Application for Project Review Garden City, Utah

DATE: February 16, 2022
TO: Town of Garden City Planning Commission
CC: Riley Argyle
FROM: Quinn Dance, P.E.
SUBJECT: Waters Edge Phase 1, 5 and 6 – Preliminary Plat

RE: Response to Bear Lake RV Resort Preliminary Plat Review by JUB (2/16/22)

LAND USE SUBMITTAL
BEAR LAKE RV RESORT
GARDEN CITY, RICH COUNTY, UTAH

EXISTING CONDITIONS PLAN

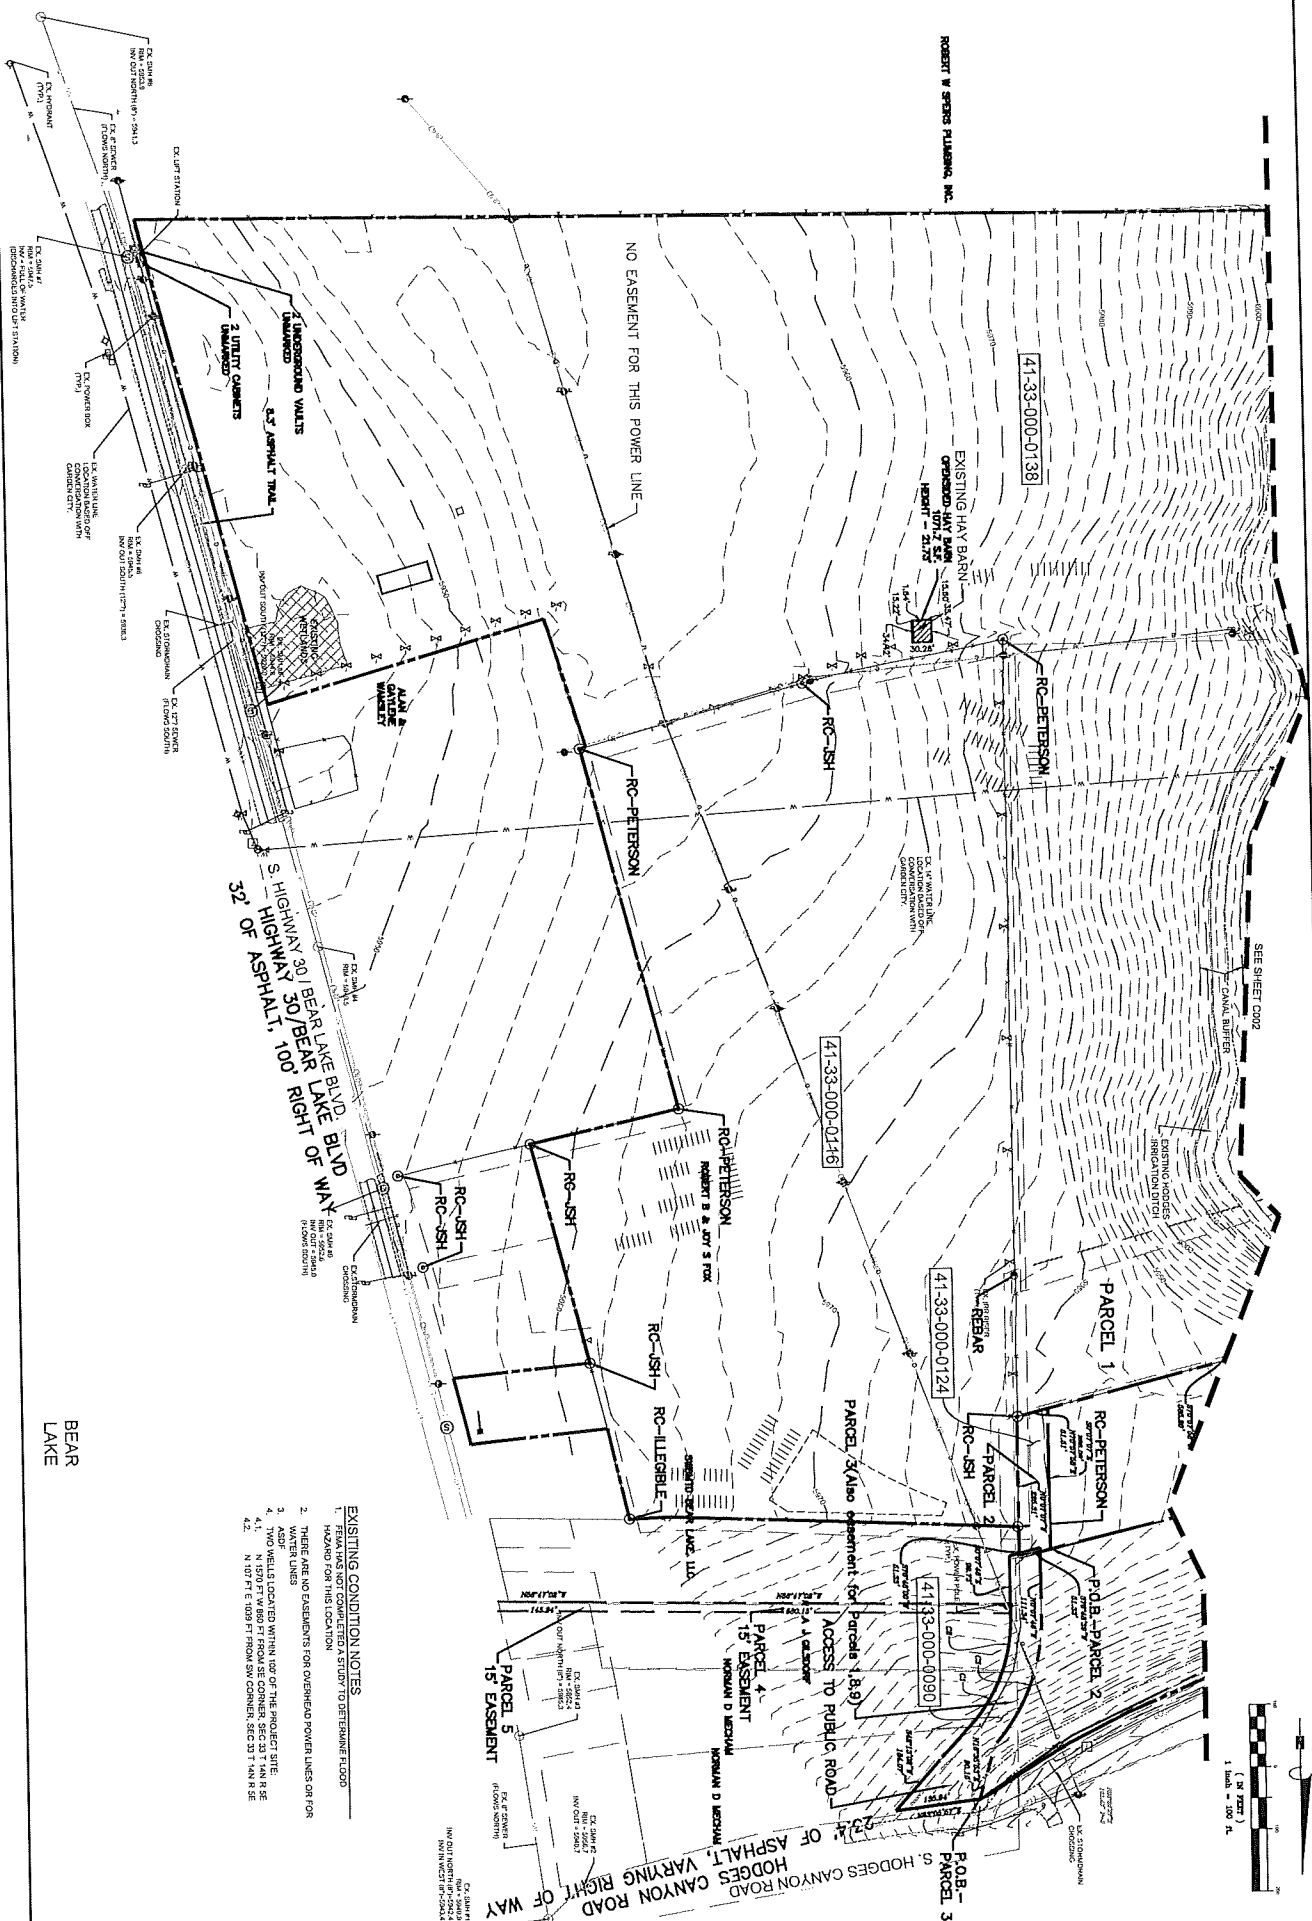
3. Include the existing wells within 100' of the development. Visit Map (utah.gov) as a potential resource for existing wells.
Response: Research indicates two wells within 100' of the property they are shown on the existing conditions plans. (Additional research ongoing)

C101

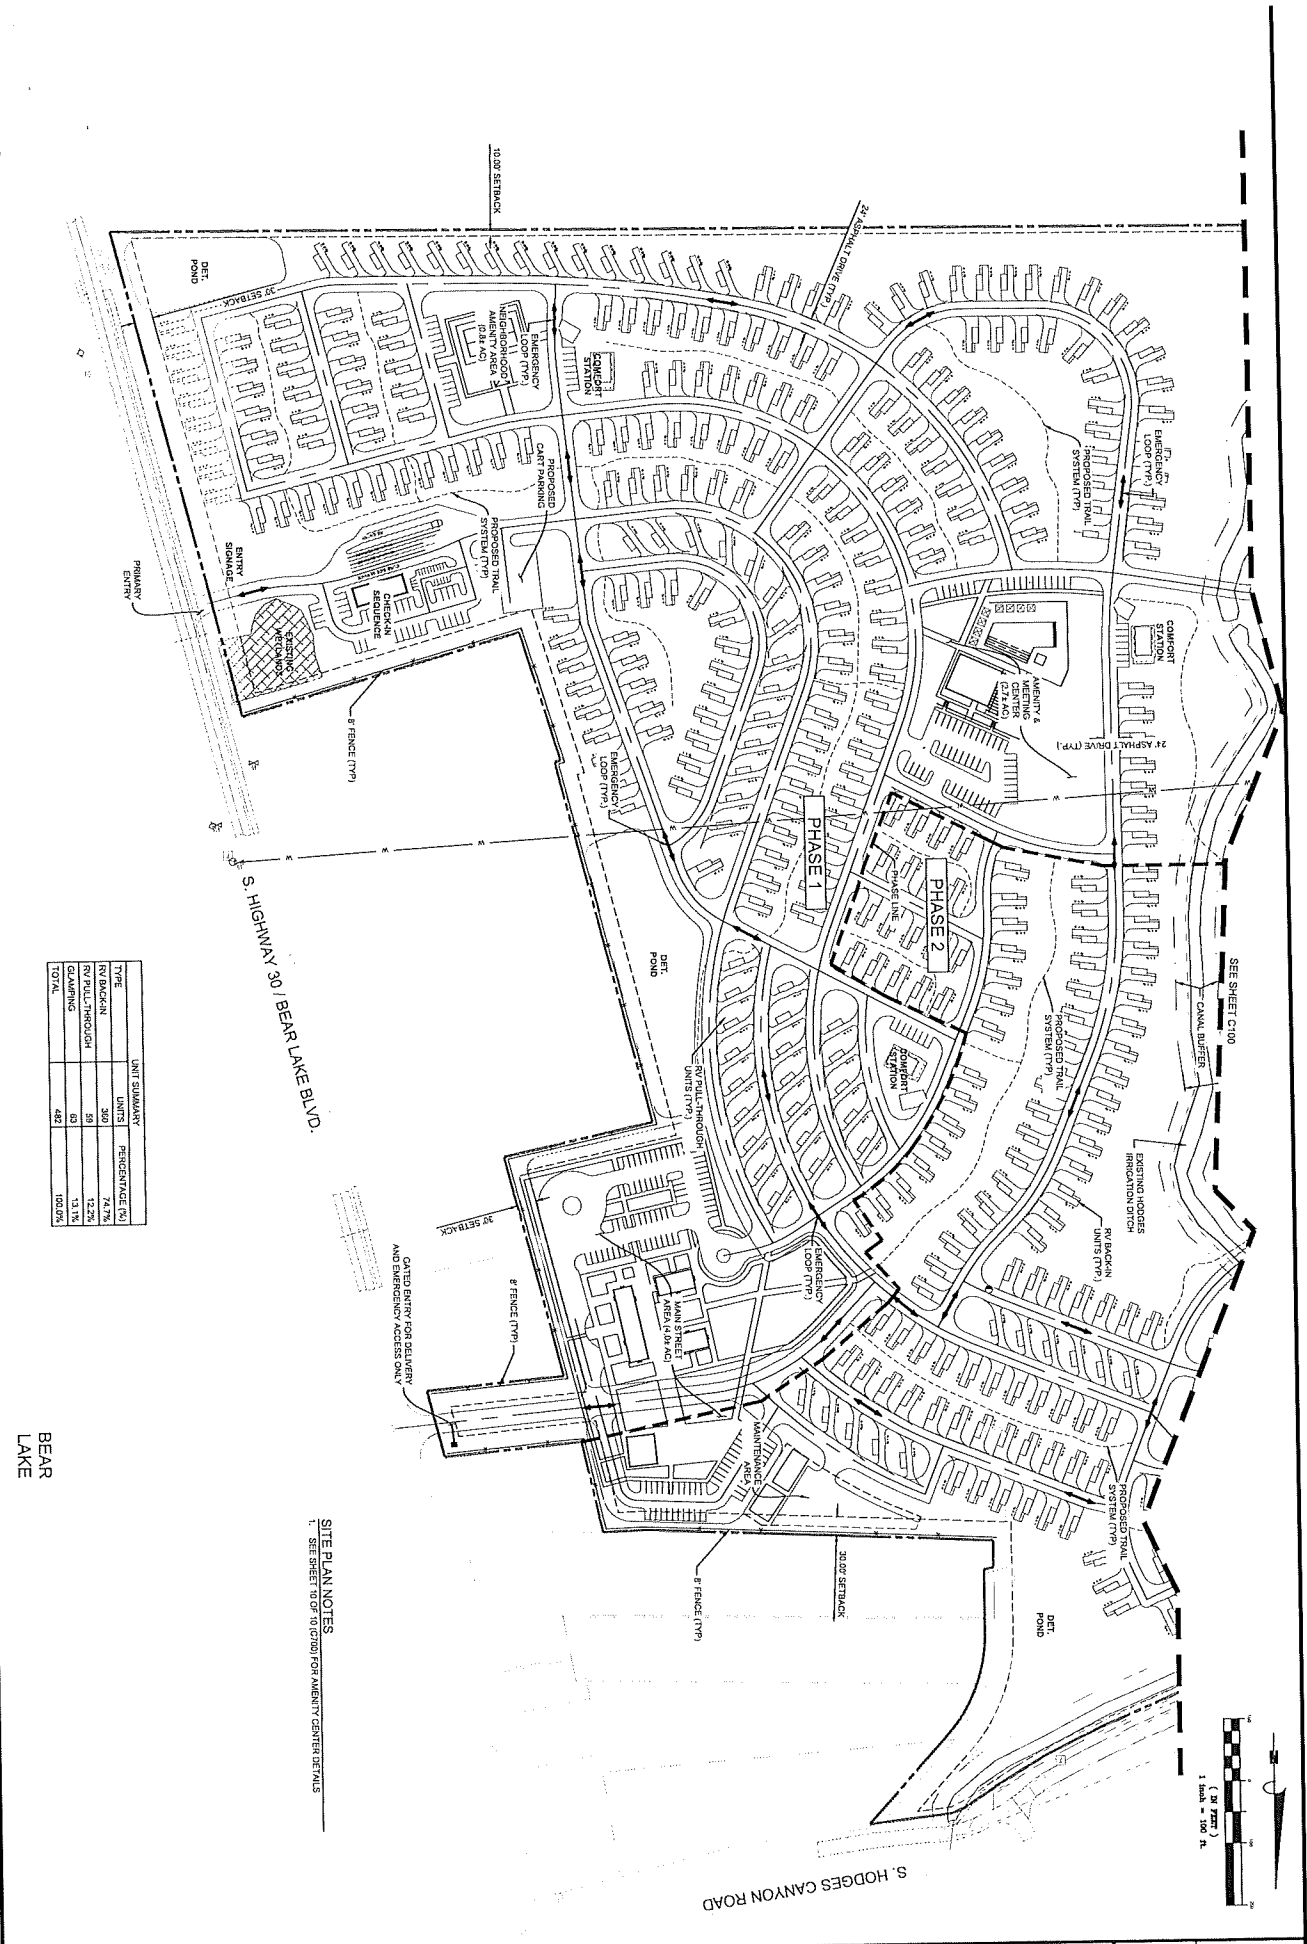
Response: Final plans will provide a detailed landscaping plan for the entire development.
10. Illustrate the location and details associated with the buffer areas that have been discussed by the Town in previous meetings.

5. Walkability may be considered within the development by the Planning Commission. Consider sidewalks/paths to move around the development without walking in the roads.

Response: The buffer and fencing adjacent to residential areas has been added to the site plans and details. (See C100, C101 and C700)
11. According to Town ordinance, a Conditional Use Permit will be required for all permanent construction to a RV (Park Model).

Response: A trail system has been added to the site plans C100 & C101.

FILE NO.
20000387
C200

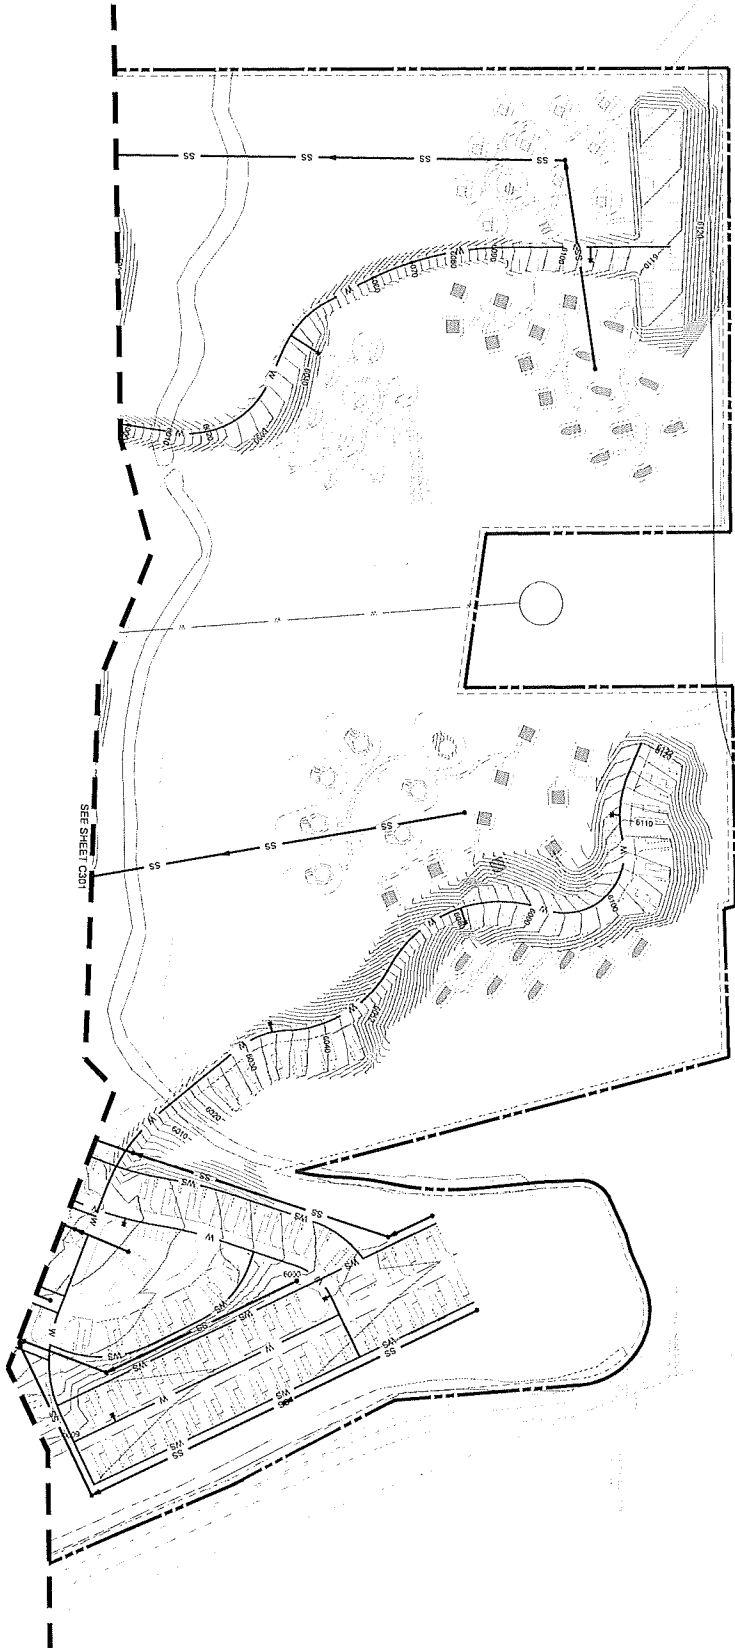
7. Proposed roads into Phase 2 will exceed 8% grade. Additional design should be considered which could include additional curves to lengthen out the run of roadway to limit the steep grades.

Response: Acknowledged. Operations of the glamping models will be seasonal and final design will provide for minimum grade requirements or restrict access accordingly during winter months.

- GRADING NOTES**
1. FINAL GRADING TO BE DETAIL IN FINAL SUBMITTAL.
 2. EMERGENCY ACCESS ROAD AND PARADISE PARKWAY TO BE GRADED IN FINAL SUBMITTAL.
 3. GRADING NOTES SHALL BE RECONSIDERED AND FINAL DESIGN WILL PROVIDE FOR UNIMPAIRED GRADING OR RESTRICT ACCESS DURING WINTER MONTHS.
